Reference: **Site Plan Application**
Purefoy Road Apartments
111 Purefoy Road
Chapel Hill, NC 27514
Pin: 9788419609

Reference: Response to Second Review Comments
Purefoy Road Apartments - 111 Purefoy Rd.

Purefoy Road Apartments

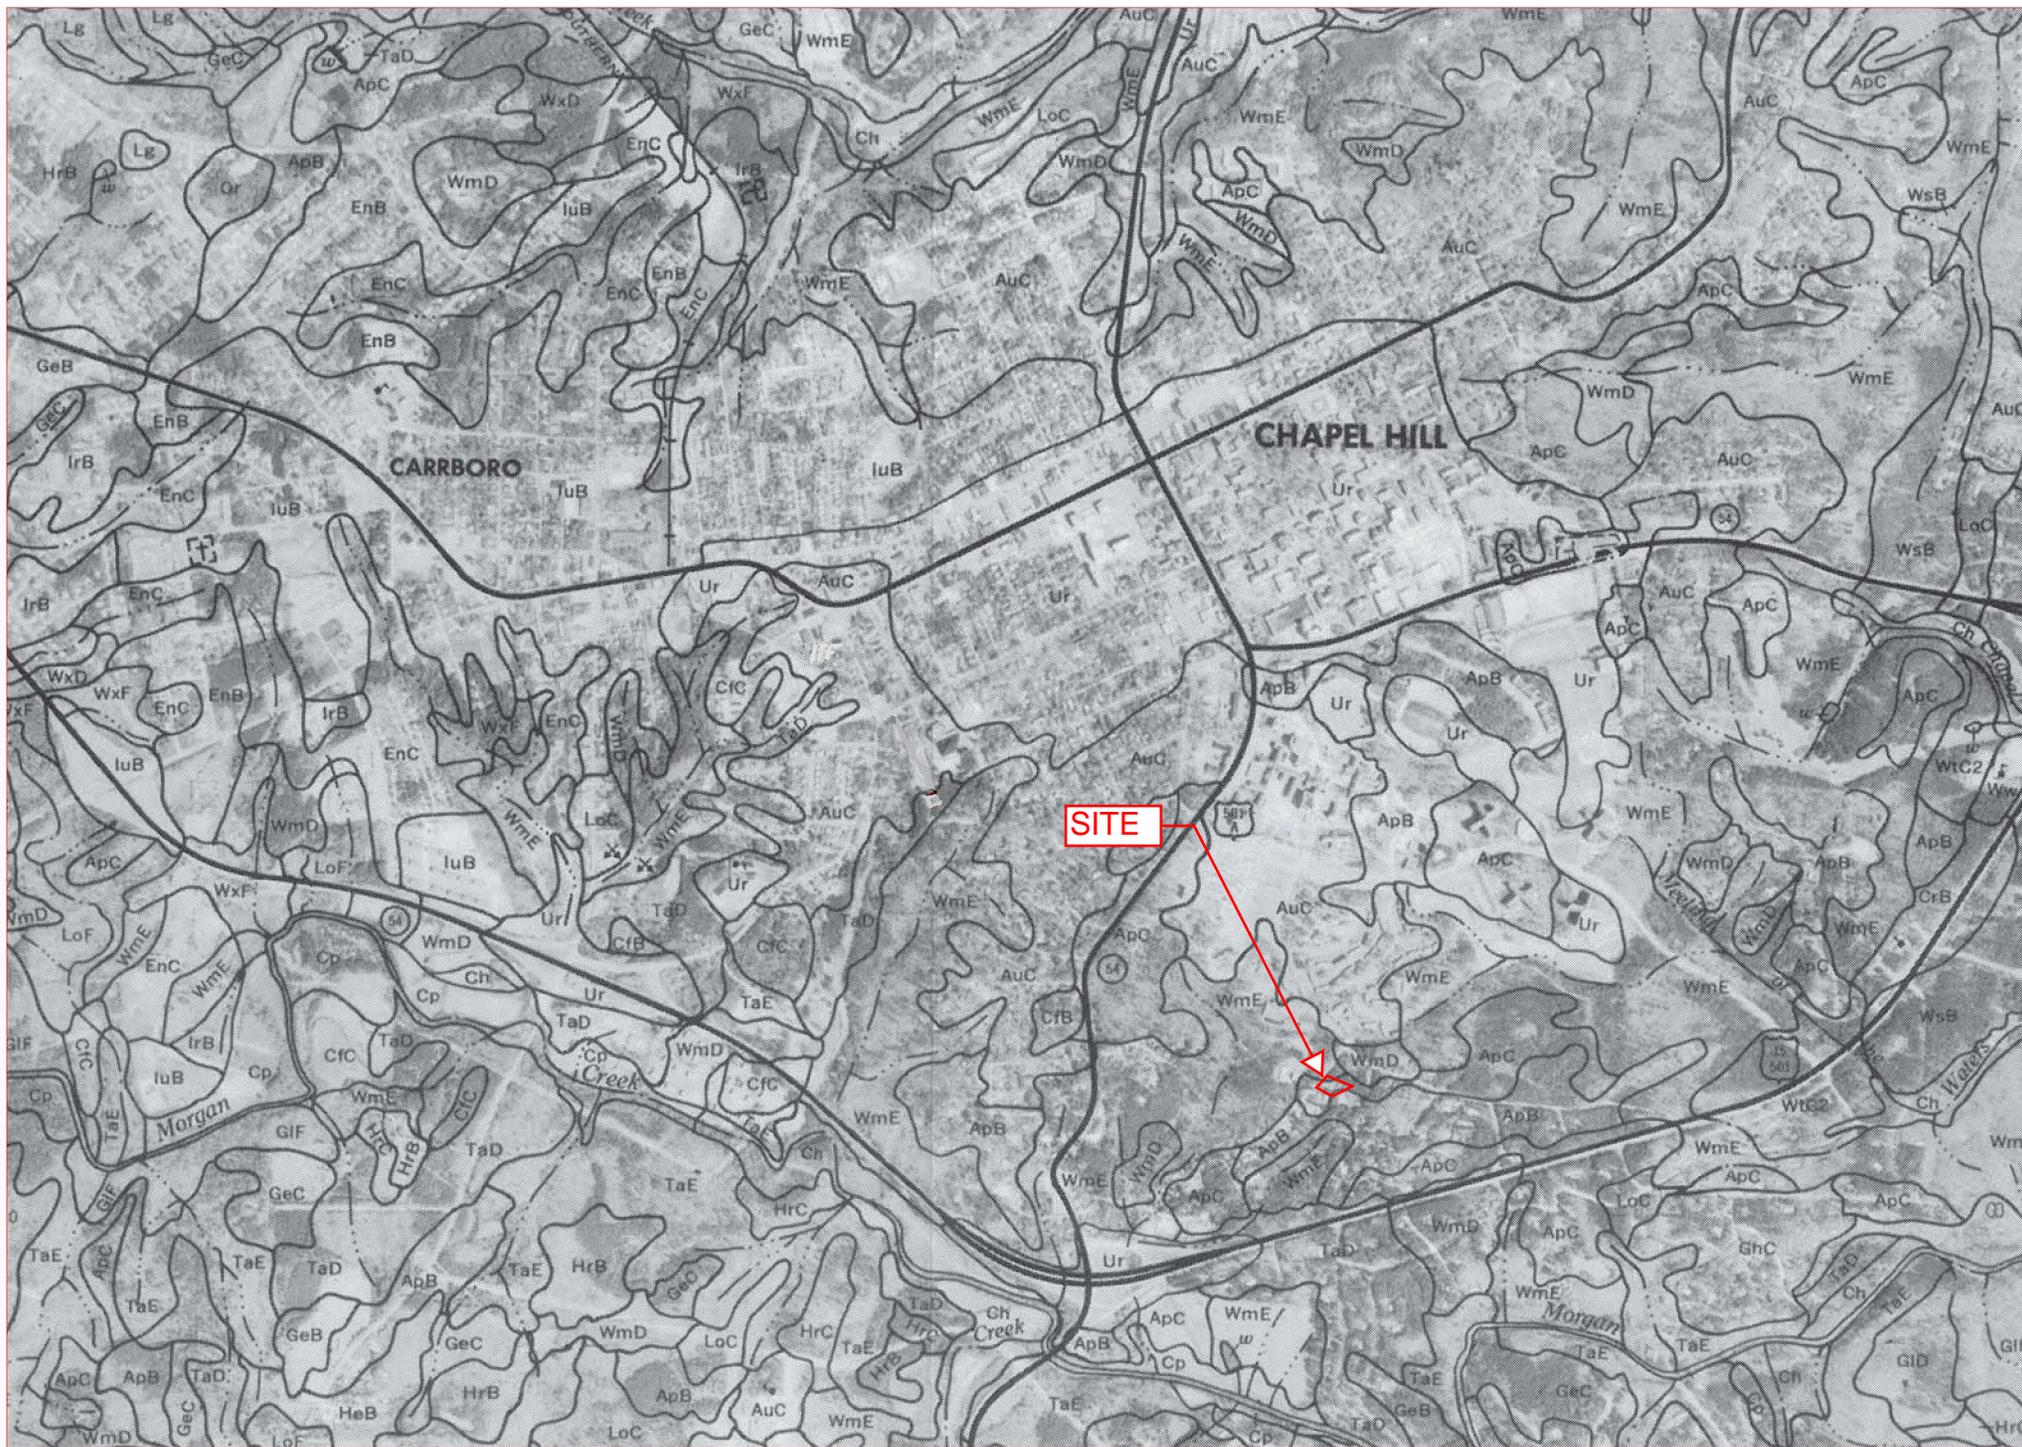
24. The post-development drainage delineation map to SCM in the calculation document is not clear to me. Differentiate the areas that drains to filterra 1 and 2 with different colors. (*Stormwater*)
Applicant Response: The post-development drainage area maps have been updated.

34. Label on the post-development drainage delineation map to SCM, the area in terms of impervious and pervious bypassing treatment and detention. (*Stormwater*)
Applicant Response: The post-development drainage area map to SCM has been updated.
